**Sent:** 24/08/2021 3:53:19 PM  
**Subject:** 8 Delecta Avenue, Clareville DA2021/1032  
**Attachments:** 8 Delecta Ave, Clareville objection letter #2.pdf; Architect's report 21\_08\_23 B submission copy.pages.pdf;

**DA2021/1032, Lot 20 DP 13291 - 8 Delecta Avenue, Clareville  
Alterations and additions**

**OBJECTION TO DEVELOPMENT APPLICATION DA2021/1032**

Alterations and Additions to a dwelling House  
at Lot 20 in DP 13291  
8 Delecta Avenue  
Clareville NSW 2107

APPENDIX – Extract form Architect's Report, pages 19 & 20

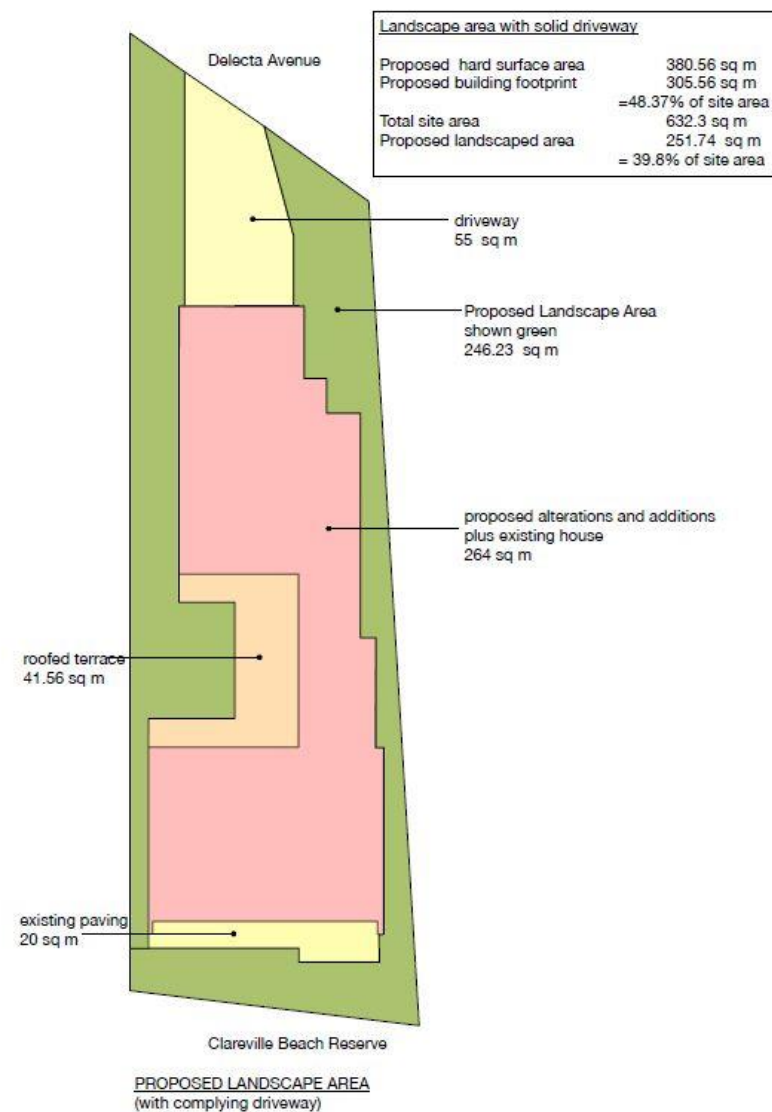
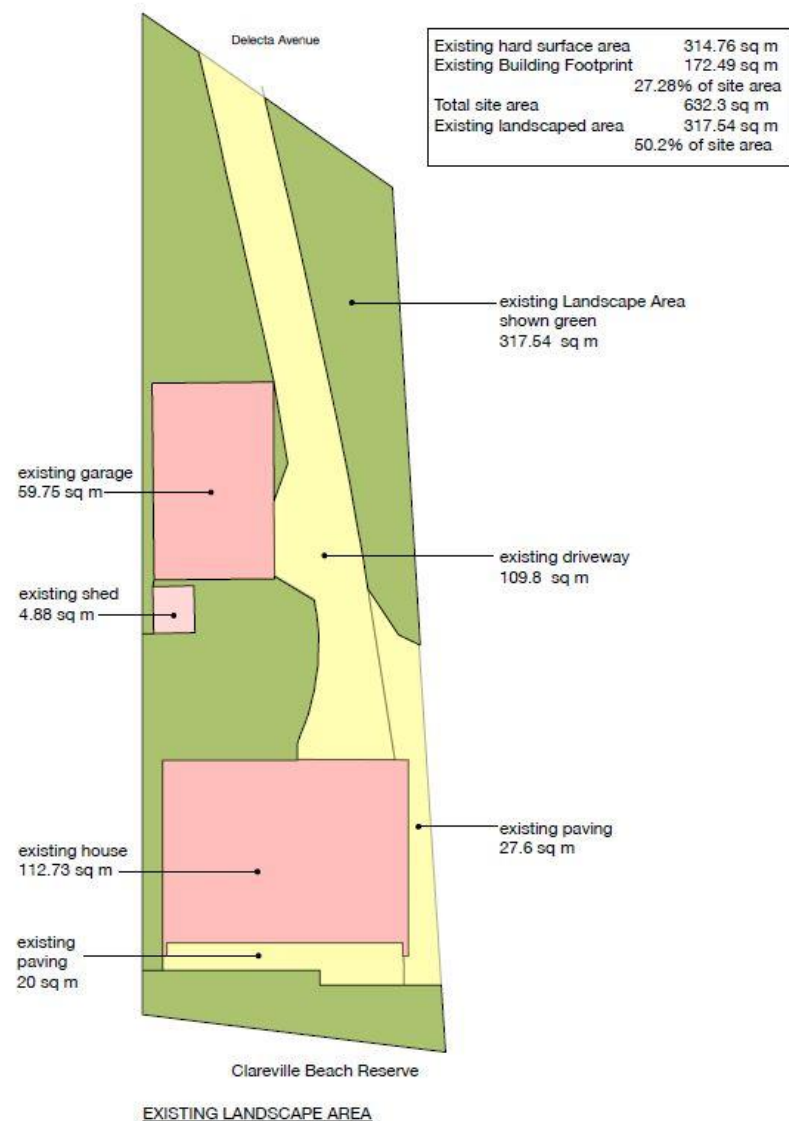
This dramatic increase in hard surface area and reduction in open space is also evident when a side by side comparison of the existing site coverage is made with the proposed development's site coverage – this is shown in the Architect's Report at pages 19 & 20, and is repeated in this letter in the Appendix. Again, the significant reduction in open space is apparent as is the increase in bulk and scale.

3. **Proposed building is excessive** – these contraventions result in a proposed building which is excessive in its site coverage. The Architect's Report demonstrates the excessive nature of the proposed development at page 8, where a model of the existing house is compared to a model of the proposed site development. If the numbers in the table above showing the increase in hard surface area are not convincing enough, then the before and after models demonstrate the significant increase in bulk and scale of the proposed development and the substantial increase in site coverage at the expense of open space.

4. **Out of scale and character** – these contraventions result in potential building impacts which are out of scale and character with existing adjacent dwellings, particularly when viewed from Delecta Avenue and also from the perspective of the residents at #6. The scale of the proposed development when viewed from #6 is massive, with an unacceptable impact on their amenity.

Image A: Model of Proposed Site Development

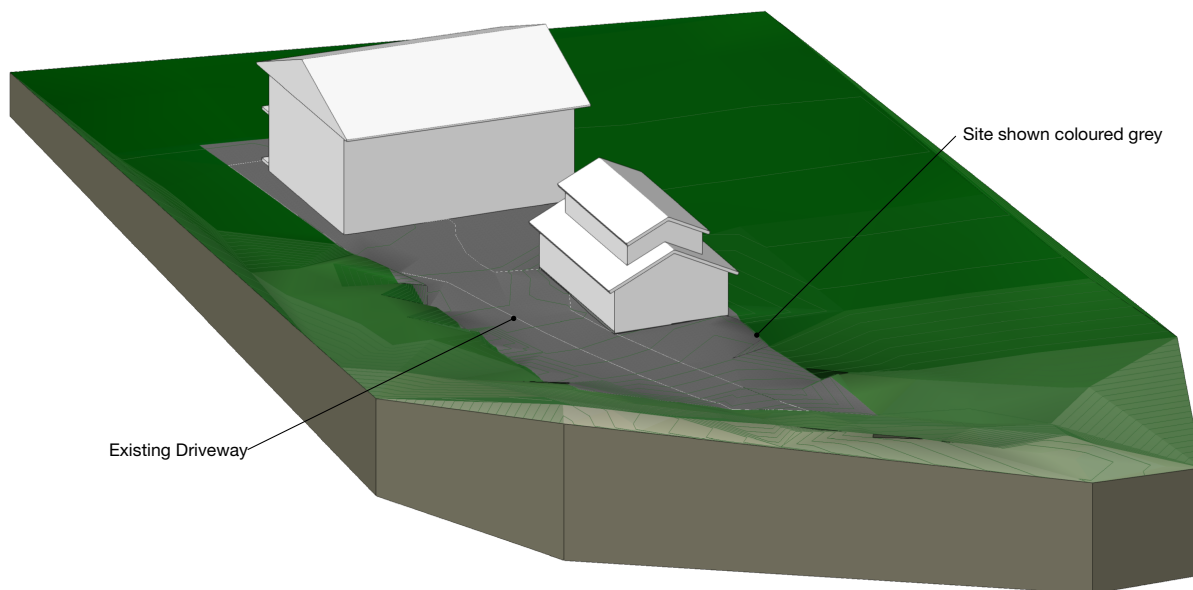
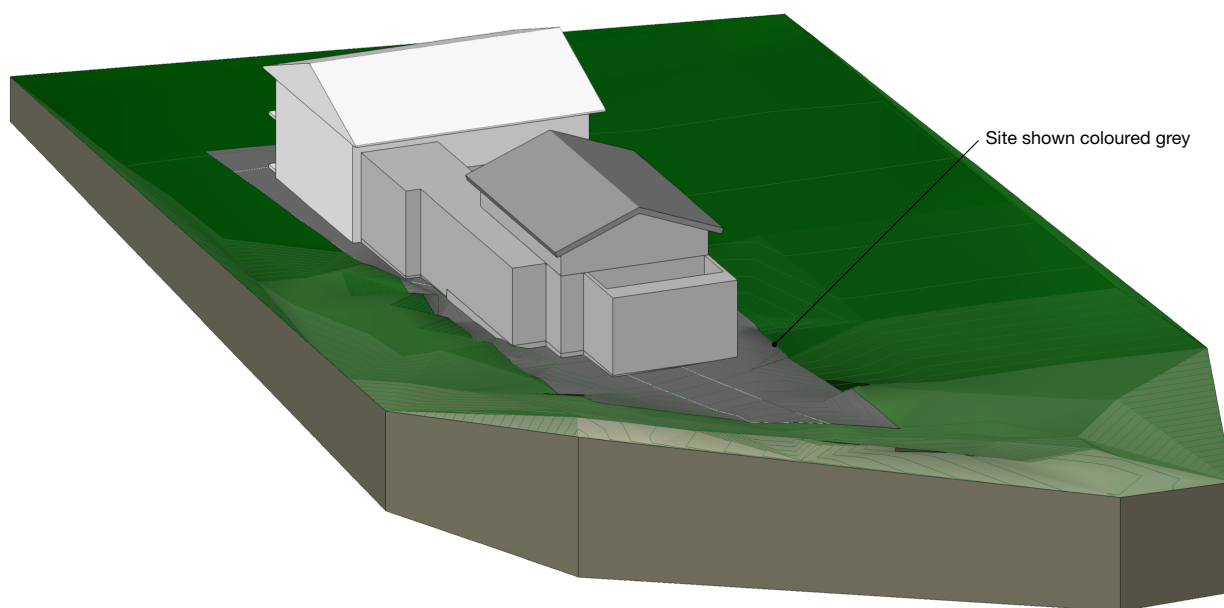
The comparison in the DA between the existing and the proposed development is misleading and specious. This is graphically shown in the following two images.

According to the DA calculations expressed in table 1, Image A has a landscaped area of 47.08% of the whereas image B has a landscaped area of 52.5% of the site.

Where Landscape Area is a control of Bulk and Scale the figures mentioned in the DA are specious and misleading.

It is clear that Image A has a large area of open space around the buildings, the buildings are of low bulk and scale, and there is the potential for much green landscaping. Image B, on the other hand, has a small amount of open space around a building with a high level of bulk and scale, with a limited opportunity for green landscaping.

Yet the DA states that Image B has more Landscape Area, and consequently less bulk and scale, than Image A. Clearly that is not actually correct.

The Respondents object to the inclusion of the roof garden in the Landscape Area, and to the implementation of wheel strips in the landscape Area equation, and believe that the proposal should conform to Part D1.14, of the DCP, and require the development to provide a minimum 60% of the site area as landscaped area.

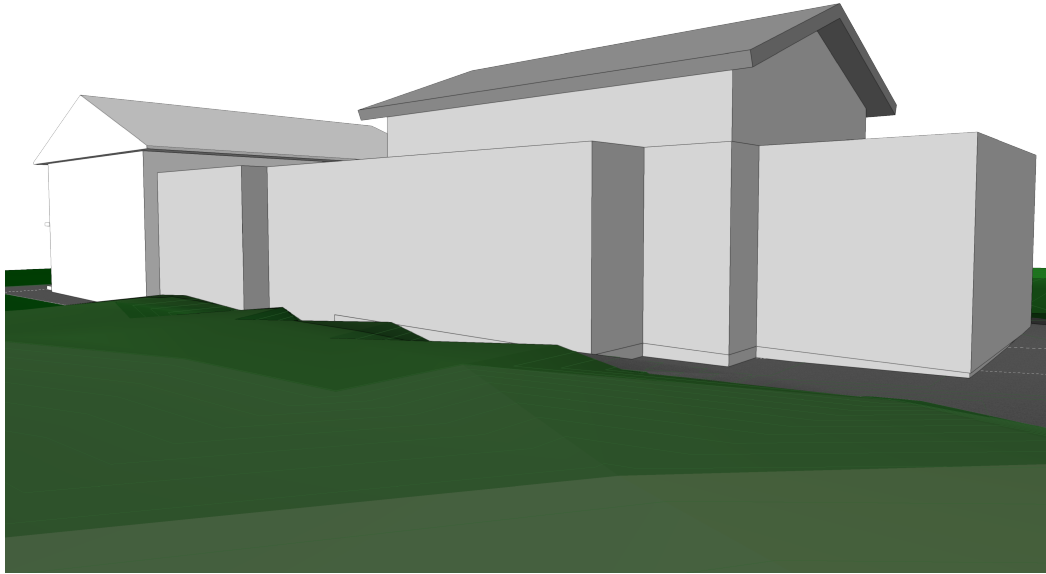
The single story brick and concrete green roof structure has an average height of 4.5 metres above natural ground level. This results from a 3.2 metre ceiling height (to part), and a 1 metre soil depth above. It is proposed to be built on the south western side of the alterations and additions, close and adjacent to the shared boundary with the house at No 6 Delecta Avenue.

The western end of the green roof joins to the eastern wall of the existing house on the site, and extends south east to the proposed front door. Here it joins the south western brick wall of the proposed garage which has the same height. The resulting combined new and existing brick wall is approximately 34 metres long.

OVERALL VIEW OF SW WALL OF PROPOSED HOUSE

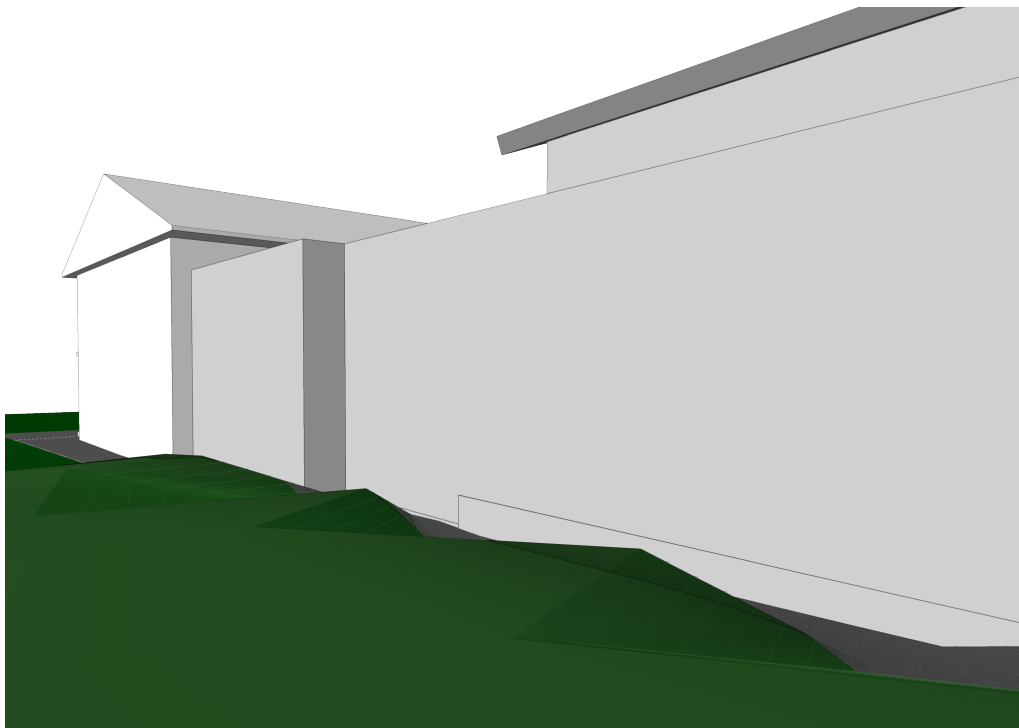
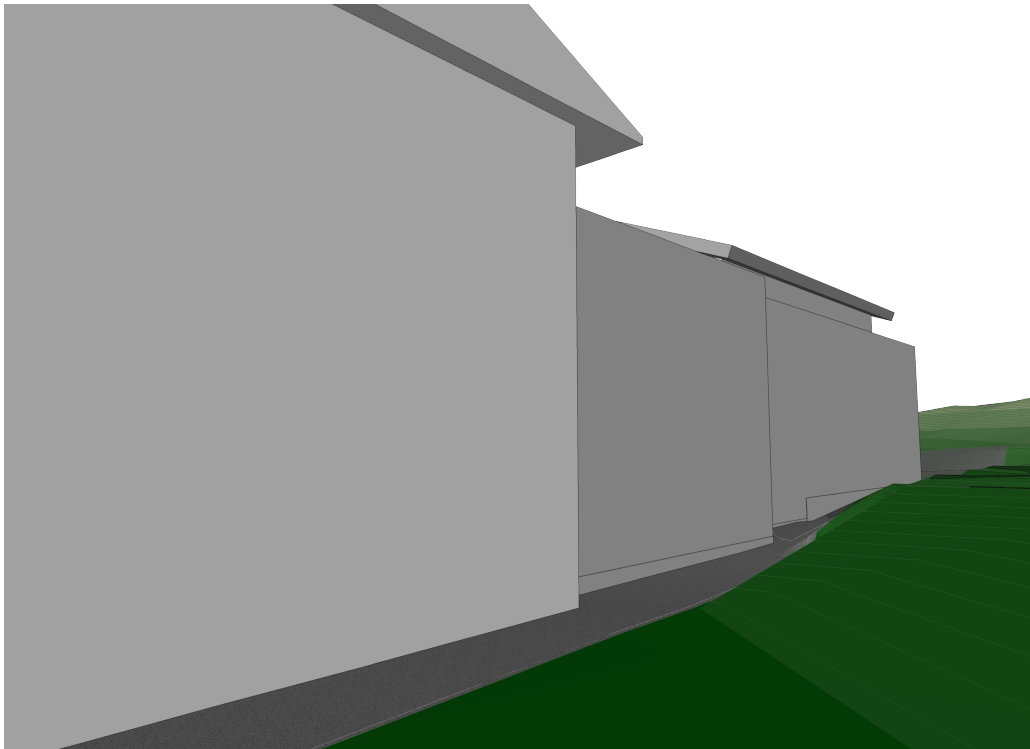
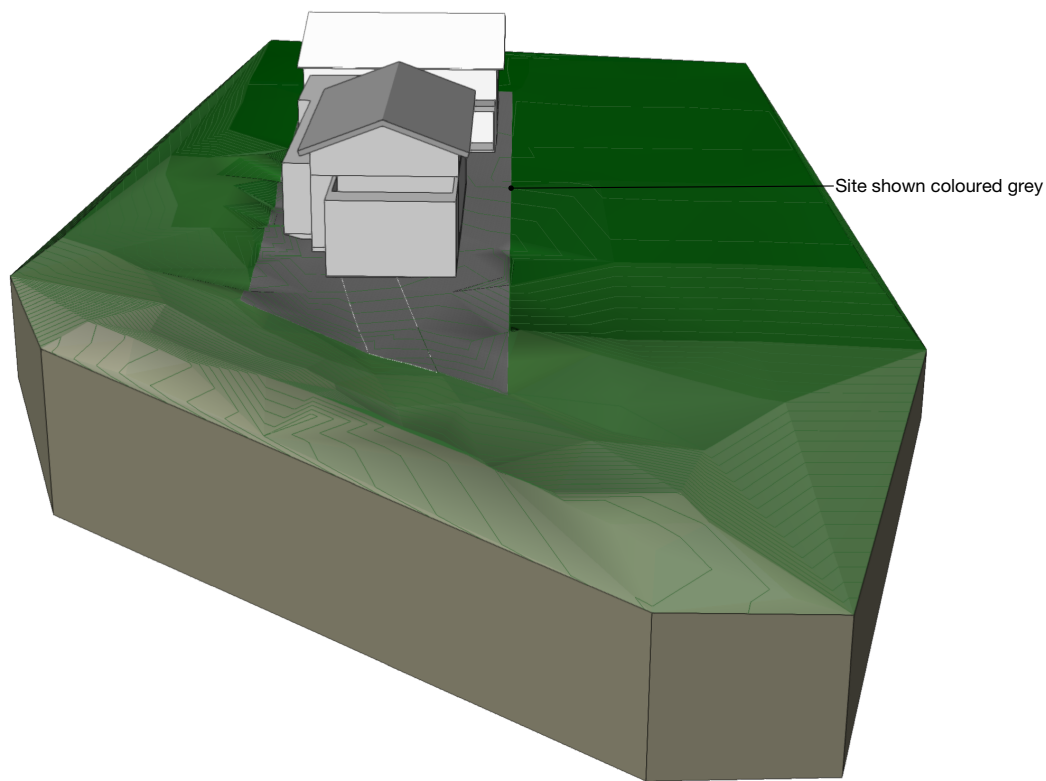
The Respondents believe the length and height of this brick expanse is out of scale with the house at No. 6 Delecta Avenue. This neighbouring house has been designed in the following manner:

In comparison, the length and height of the south western wall of the proposal is a relatively massive proposed structure. It does not acknowledge the good neighbourliness of the house at No. 6, or pay heed to the maintenance of the canopy tree which the owner's of No. 6 Delecta Avenue worked hard to preserve.

The Respondents do not understand why this building element is so massive, out of scale, and out of context with its surroundings.

The Respondents believe that the bulk and scale of the green roof structure is unnecessary and that it could be replaced with a lower, lighter weight structure with metal roof, located further away from the boundary, with more varied modulation to its edge and fenestration, and a marked reduction in bulk and scale. This structure could be located further away from the Melaleuca , with a lighter floor structure and footing system that would allow the tree to remain. A lower structure would also allow the branches of the tree to remain in place.
